# FINAL ENVIRONMENTAL IMPACT REPORT

### LIDO HOUSE HOTEL

### SCH NO. 2013111022

### 2.0 RESPONSE TO COMMENTS

INGRESS EXHIBIT 2A

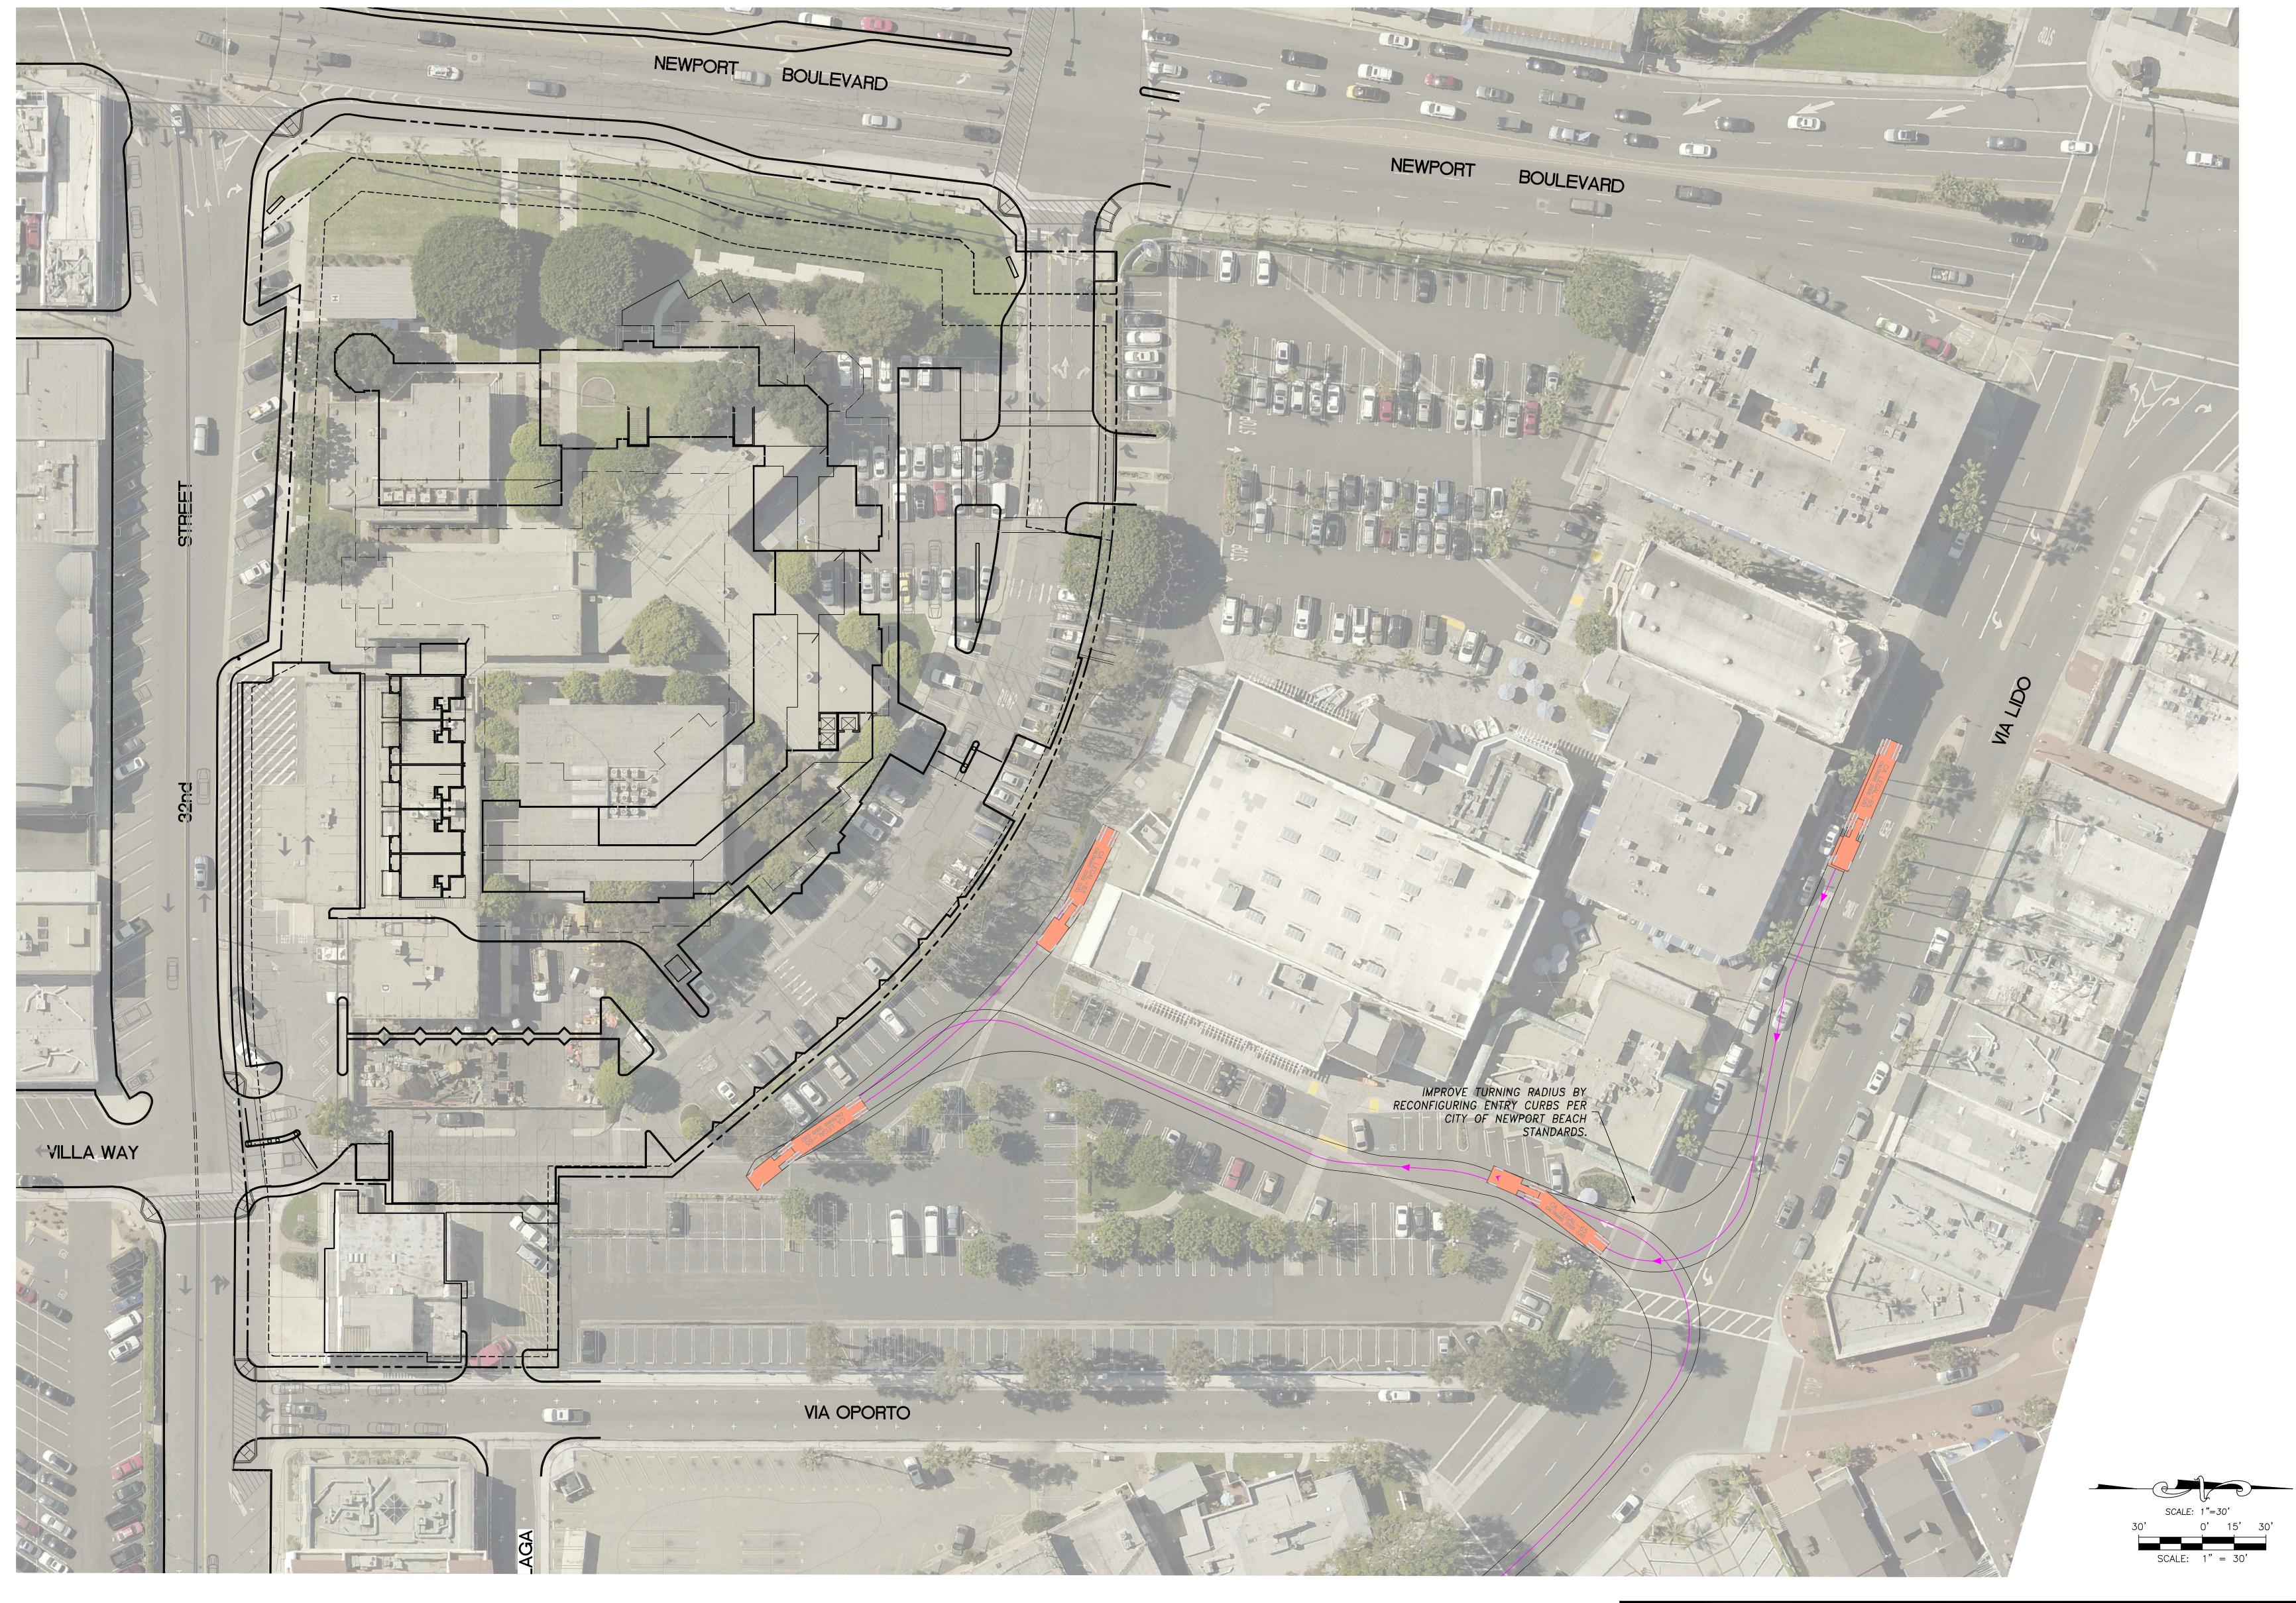
The City acknowledges that closure of the driveway will require that the operations at Via Lido Plaza facilitate delivery traffic at either of the other two driveways. The turning radius graphic included with the comment letter as Attachment A does show the difficulty of the largest delivery truck attempting to make a right turn from the #2 lane of eastbound Via Lido without using the entire driveway on Via Lido Plaza. In reviewing the access exhibit provided in Attachment A of the comment letter, the City acknowledges that access for the largest delivery truck from Newport Boulevard/Finley Avenue through the existing parking lot entry may not be feasible due to the design features installed by the owners of Via Lido Plaza. However, these design features do not preclude access by trucks that are smaller and more maneuverable. The City concurs that egress from the truck dock on the Via Lido property to Via Lido is viable, as shown in the upper middle view of the same referenced exhibit. However, the City respectfully takes exception to the entry analysis from Via Lido as shown on the truck turn study provided in Attachment A of the comment letter. The exhibit assumes a vehicle is present in the northbound exit lane of the Via Lido Plaza driveway, thereby restricting access. While a vehicle in this position would restrict access, the same condition exists while entering from 32<sup>nd</sup> Street to the existing driveway (refer to Exhibit 1, Existing Conditions, which was prepared by Fuscoe Engineering and is included in

Entry access from Via Lido also appears to be an easier maneuver than using the 32<sup>nd</sup> Street driveway entry as it requires only a single backing maneuver(refer to Exhibit 2A, Ingress, which is included in Attachment 1 of this response) while the 32nd Street entry indicates a three point turn is required for access to the truck dock. As an alternate access scenario, Fuscoe Engineering also routed a truck from eastbound 32<sup>nd</sup> Street, north onto Lafayette Road and northwest onto Via Lido (refer to Exhibit 2B, Ingress, which is included in Attachment 1 of this response). This path provides access to the Via Lido property from the westbound left lane of Via Lido, avoiding entering Via Lido from Newport Boulevard. Access to the truck dock facility located in Via Lido Plaza is viable from Via Lido from either direction, and would provide easier truck movement on the Via Lido property than is possible by using the 32<sup>nd</sup> Street driveway as Fuscoe Engineering's analysis indicates that truck traffic can readily enter from Via Lido without interference. It should also be noted that scuff marks on the existing curb returns indicate that vehicle tires have rubbed the curb face in the past. If upon final design the City considers it necessary to address this minor access limitation from Via Lido, the existing driveway approach curb aprons would be improved to accommodate a larger radius using current City of Newport Beach standards as guidelines to provide additional room for maneuvering.
